ADDENDUM No. 7 – February 20, 2019

This addendum modifies, amends, and supplements designated parts of the Contract Documents for the above project and is hereby made part thereof by reference and shall be as binding as though inserted in locations designated hereunder.

1 FP004 **B2 Ground - Auto Diesel Lower Main Pipe Size Clarified**
Scale: 1/8" = 1'-0"

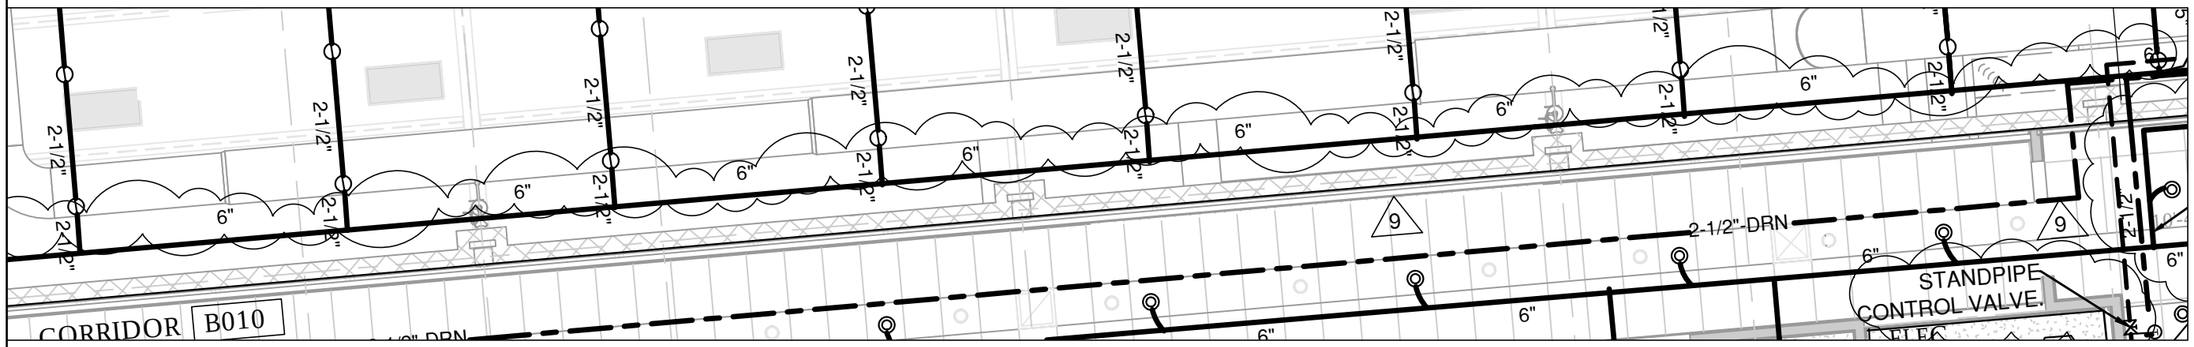
A. Delete all intermediate temperature upright sprinklers within Mechanical B004 and Custodian Workshop B004.1, and replace with high temperature upright sprinklers.
B. Refer to Sketch ADD-7/FP.002
C. Refer to Sketch ADD-7/FP.003
D. Refer to Sketch ADD-7/FP.004
E. Refer to Sketch ADD-7/FP.005
F. Refer to Sketch ADD-7/FP.011

1 FP006 Cafeteria - Missing Sprinklers Turned On

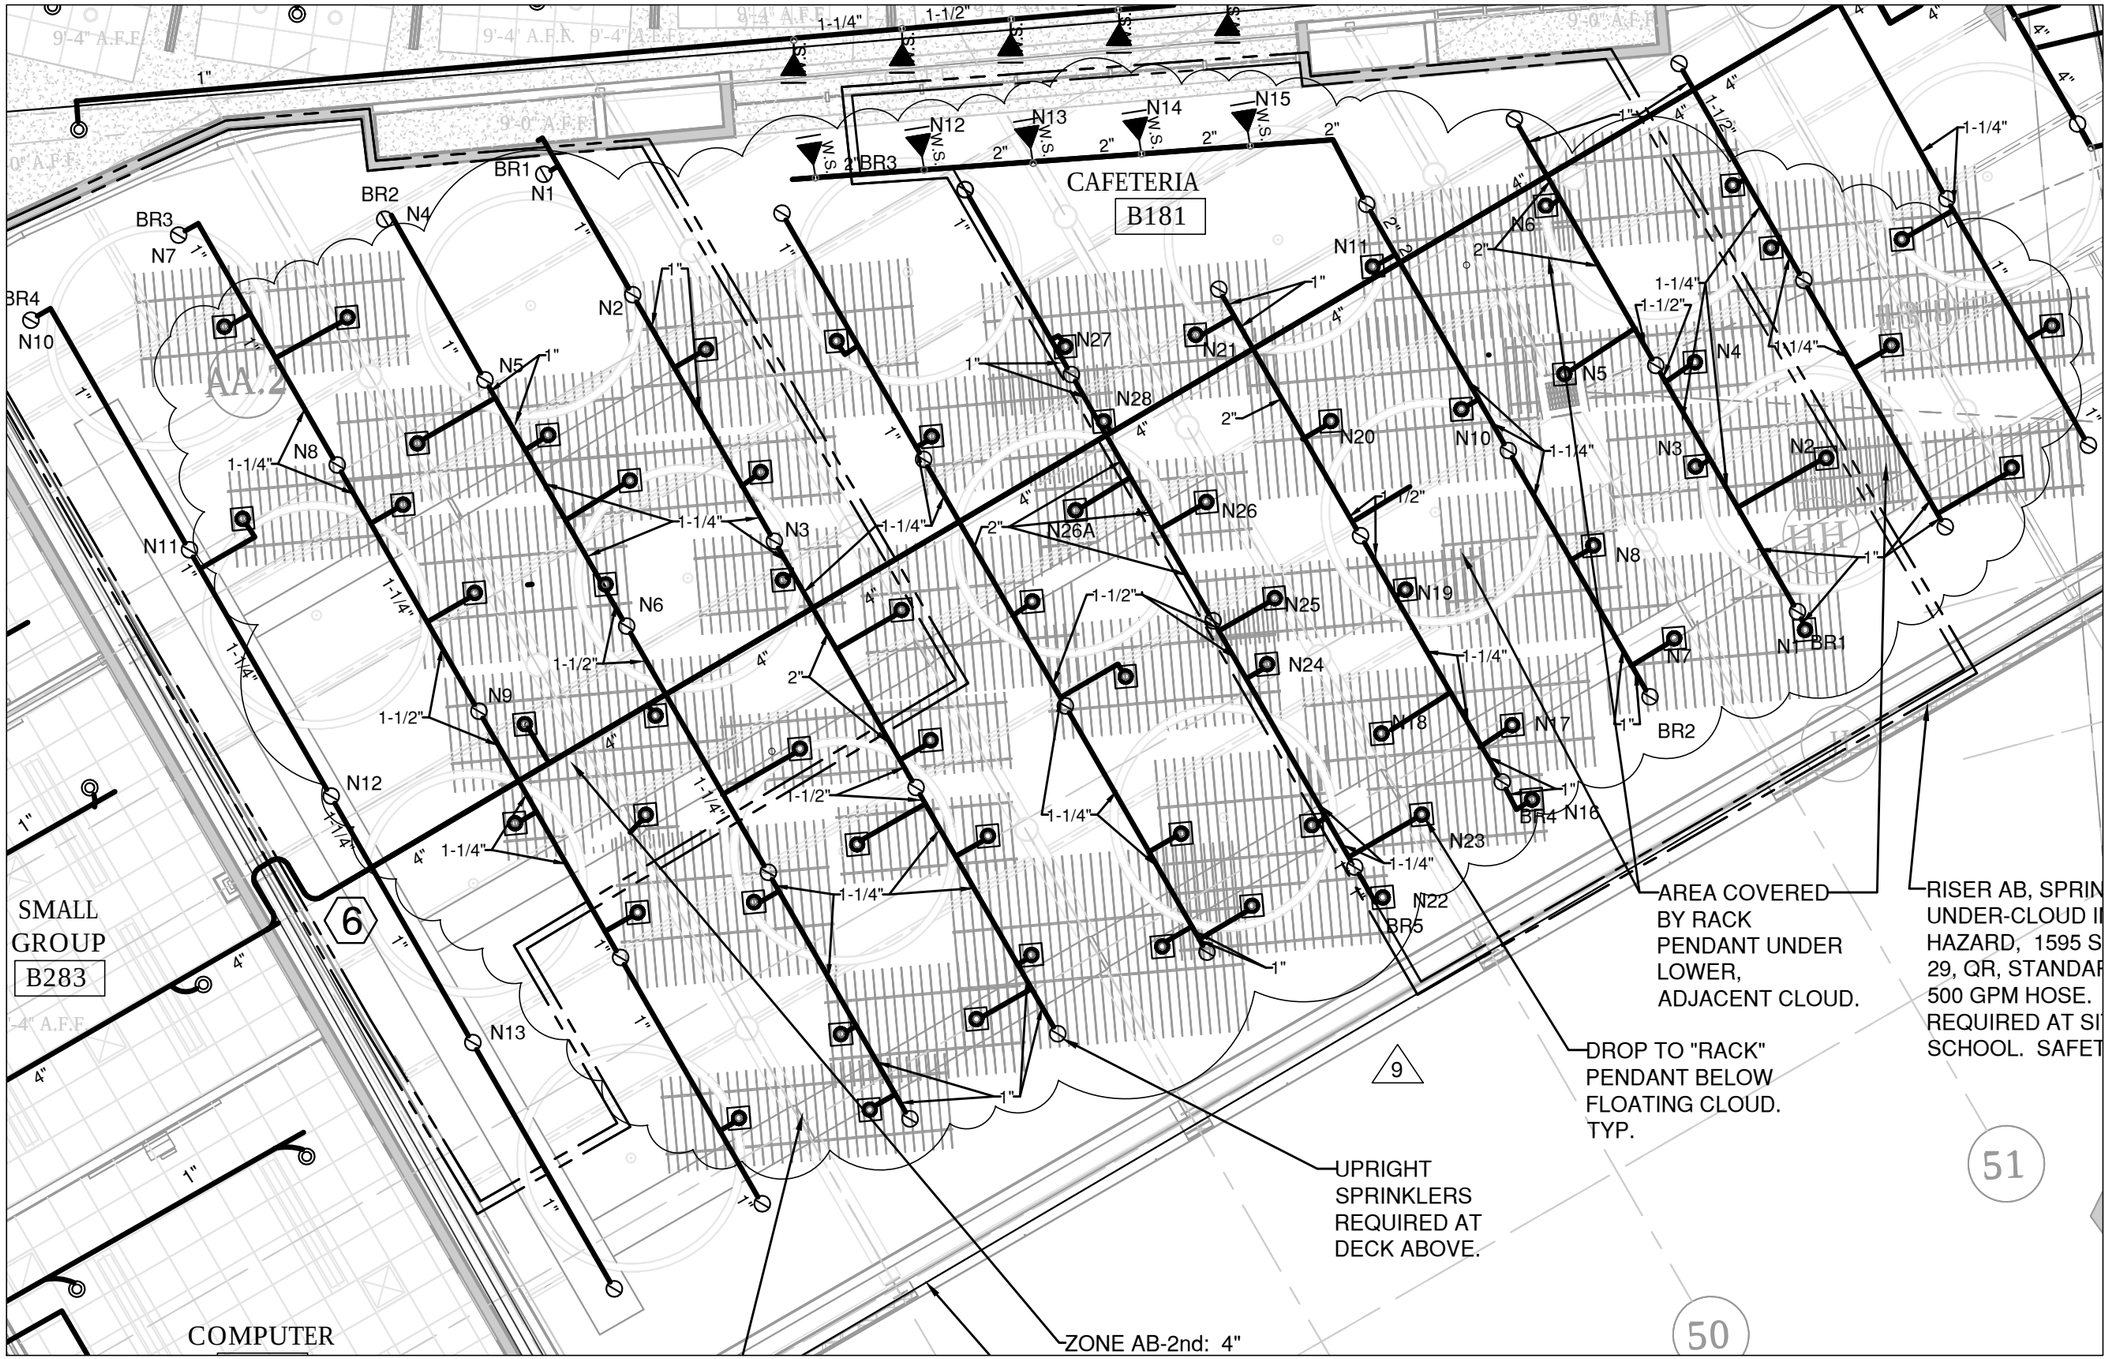
A. Refer to Sketch ADD-7/FP.003
B. Refer to Sketch ADD-7/FP.005
C. Refer to Sketch ADD-7/FP.006

1 / FP010 **Service Entrance Revisions**

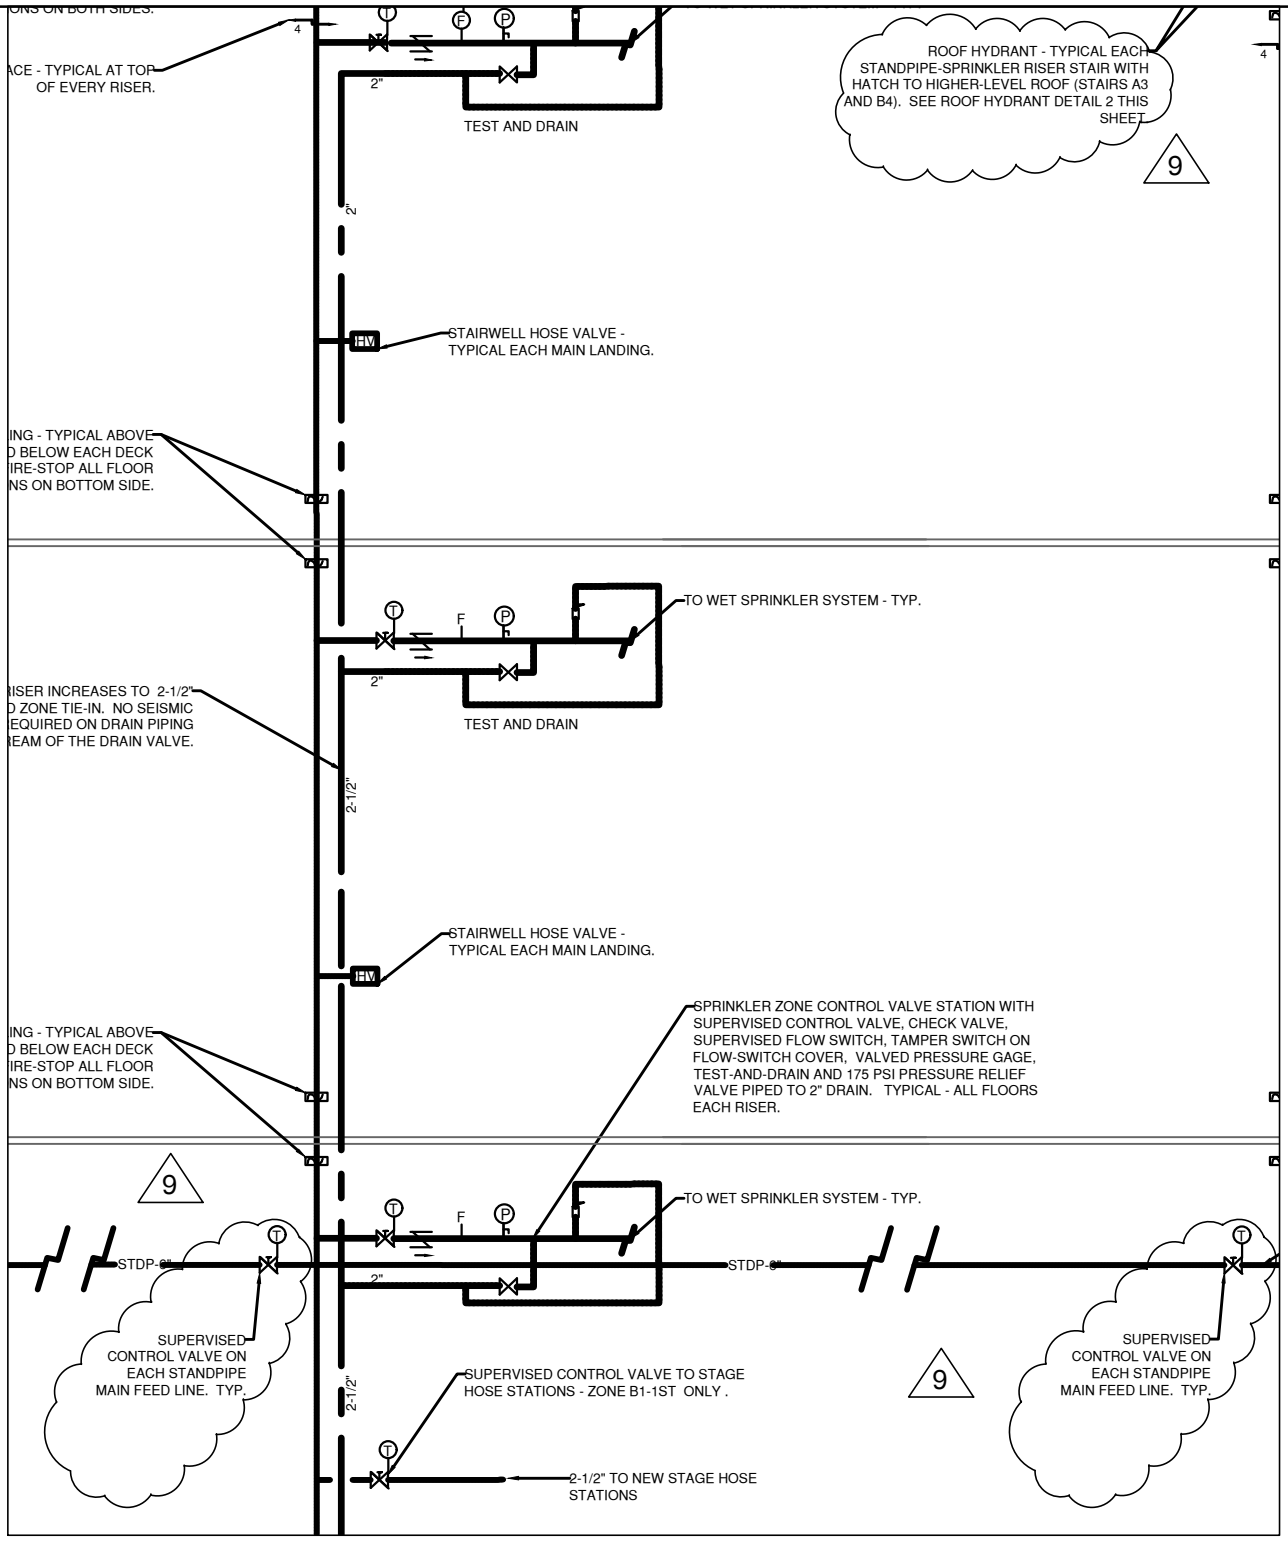
A. Refer to Sketch ADD-7/FP.002
B. Refer to Sketch ADD-7/FP.003
C. Refer to Sketch ADD-7/FP.010

SITE IRRIGATION SYSTEM CONNECTION DETAIL

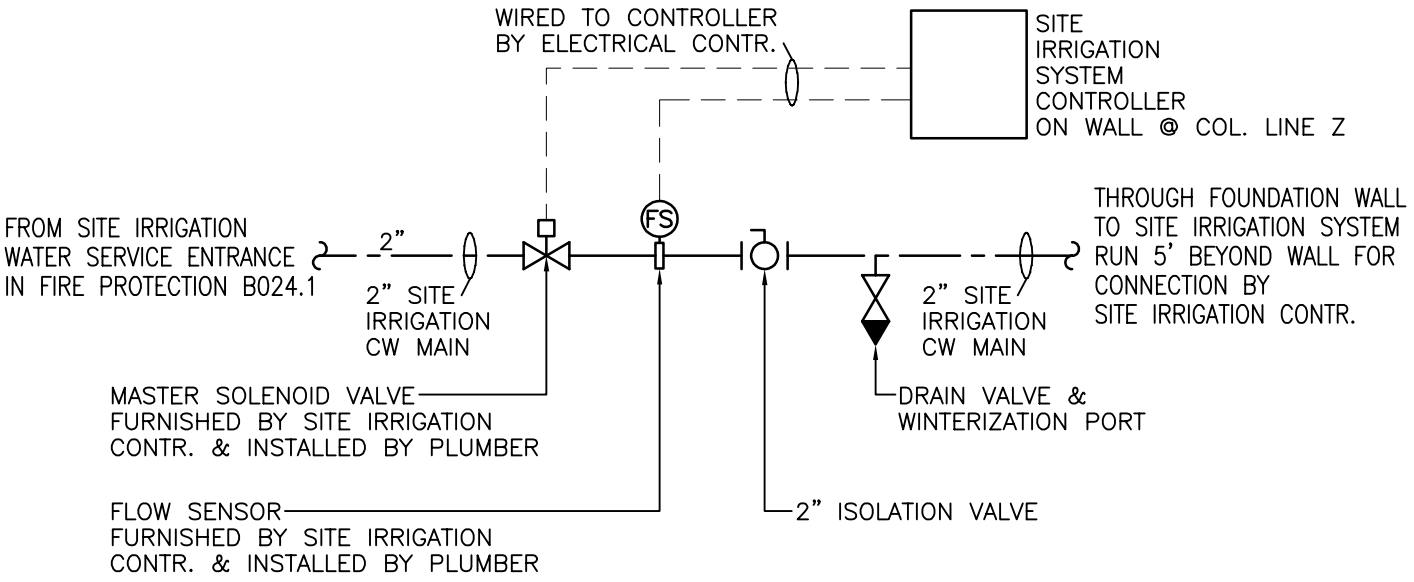
A. Detail 1/P4.5 Partial First Floor Plumbing Plan Section B1: In Men B174, the note for the wet-wall with water closets and urinals is incorrect. It should read as follows: “2”V Rise for P-2, (2)2”V Rise for P-1’s, 1-1/2”V Rise for P-5, (2)1-1/2”V Rise for P-4’s, 4:W DN, 1-1/2”CW Drop.
B. Detail 5/P4.5 Partial Ground Floor Plumbing Plan Section B1: In Janitor B073, provide signage for H.B. that this is for soap/chemical dispenser connection only.ed cp cp
C. Detail 14/P4.5 Partial Ground Floor Plumbing Plan Section B2: Site Irrigation System Control Panel in on the long outside wall. Also, note that “For 2” Site Irrigation System water feed, see ADD-7/P001 for piping/valving detail.

DRAWING NAME:
Lighting - Catwalk 3 Detail - 9/E1.14

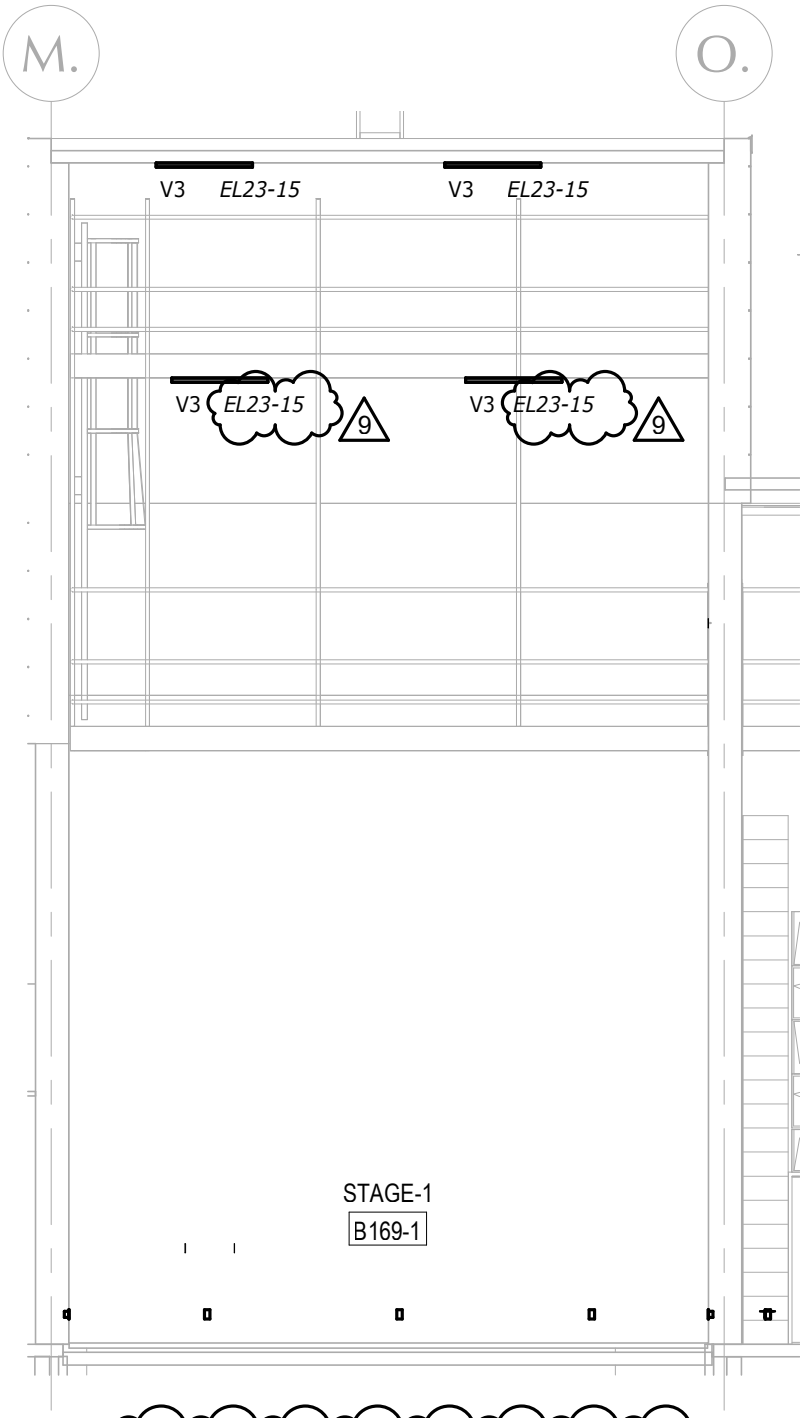
A. Refer to Sketch ADD-7/E-005

DRAWING NUMBER:
ADD-7
E-007

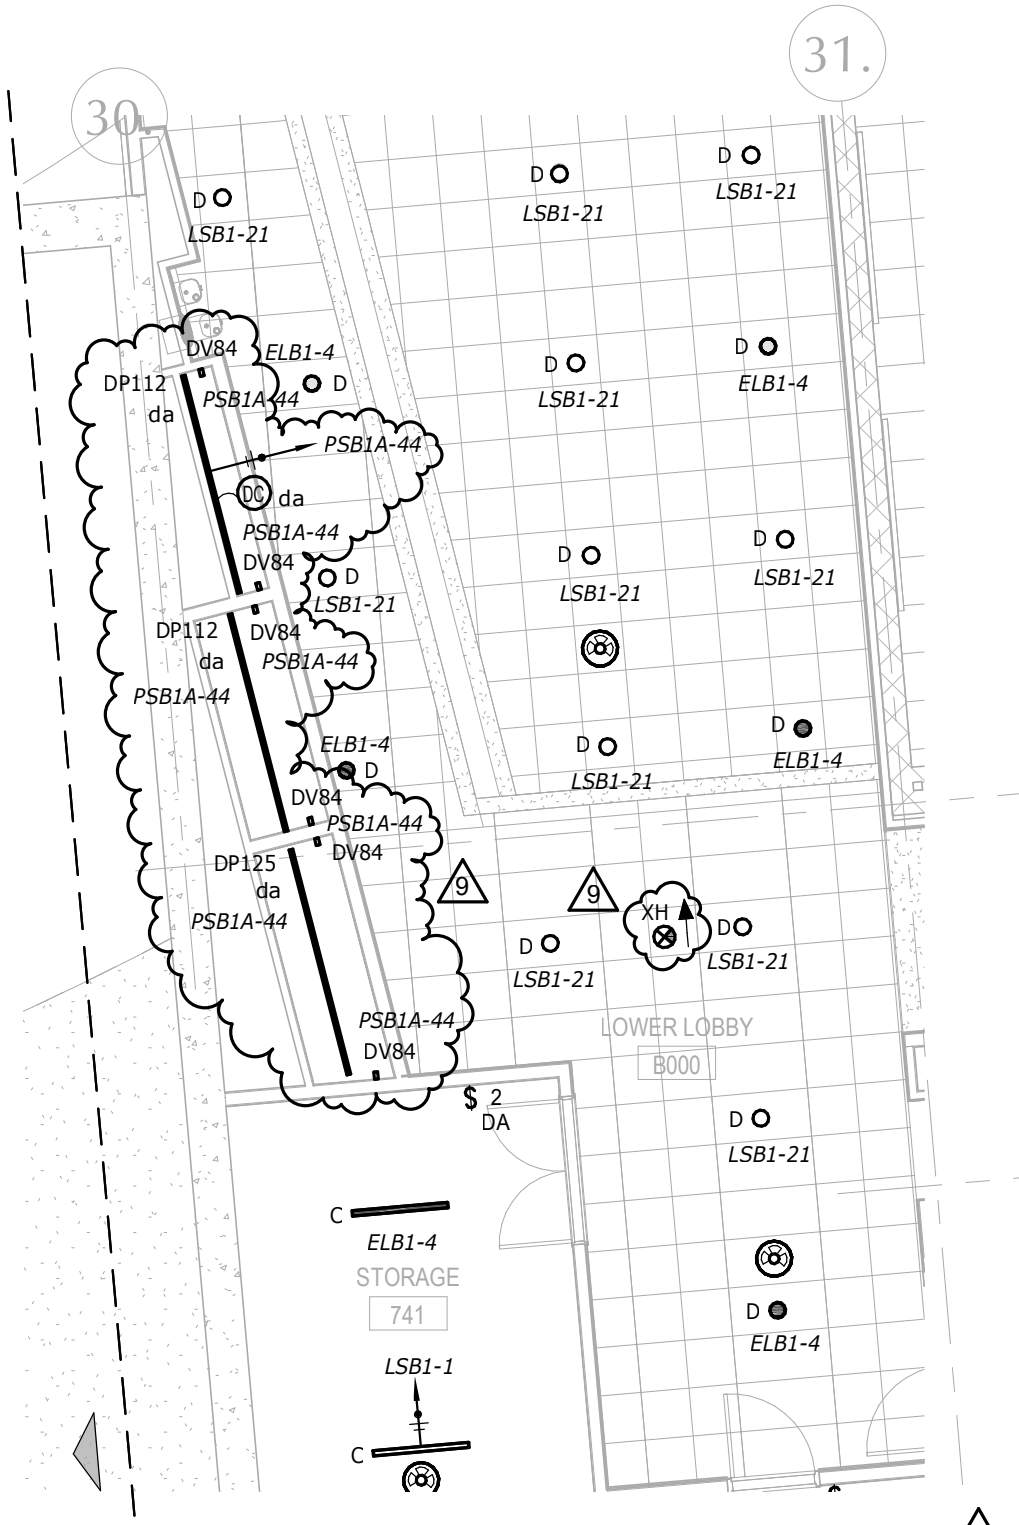
A. Change all exit signs shown on this drawing to type XH, except for in Mechanical B0004 and Electric B006. Change all exit signs type X2 to type X2H. In Auto/Diesel Shop B023, change exit sign between grid lines 35 and 35.6 to type X2H.
B. Refer to Sketch ADD-7/E-007

NOTES:
1. REVISE VOLTAGE FOR LIGHT FIXTURE TYPE DP112 AND DP125 TO 120V.
2. ADD VERTICALLY MOUNTED (AT JAMBS) LIGHT FIXTURES TYPE DV84.
3.ADD EXIT SIGN,

DRAWING NUMBER:
ADD-7
E-014

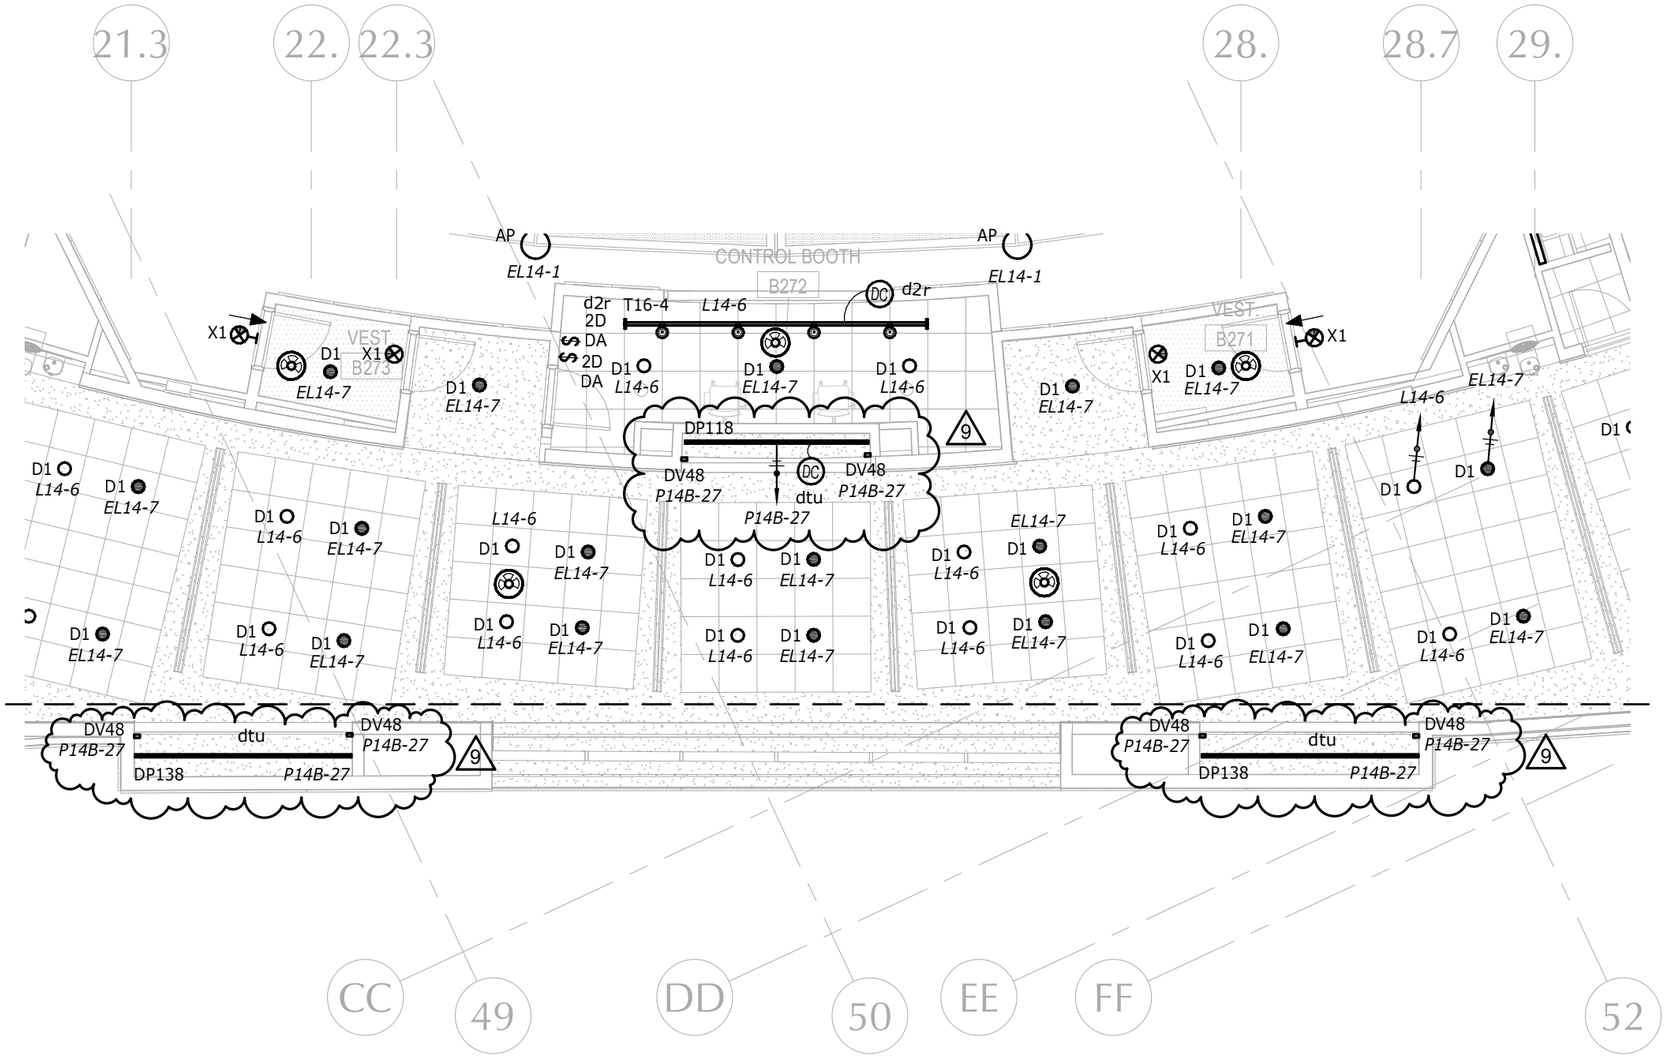
NOTES:
1. REVISE VOLTAGE FOR LIGHT FIXTURE TYPE DP118 AND DP138 TO 120V.
2. ADD VERTICALLY MOUNTED LIGHT FIXTURES TYPE DV48.
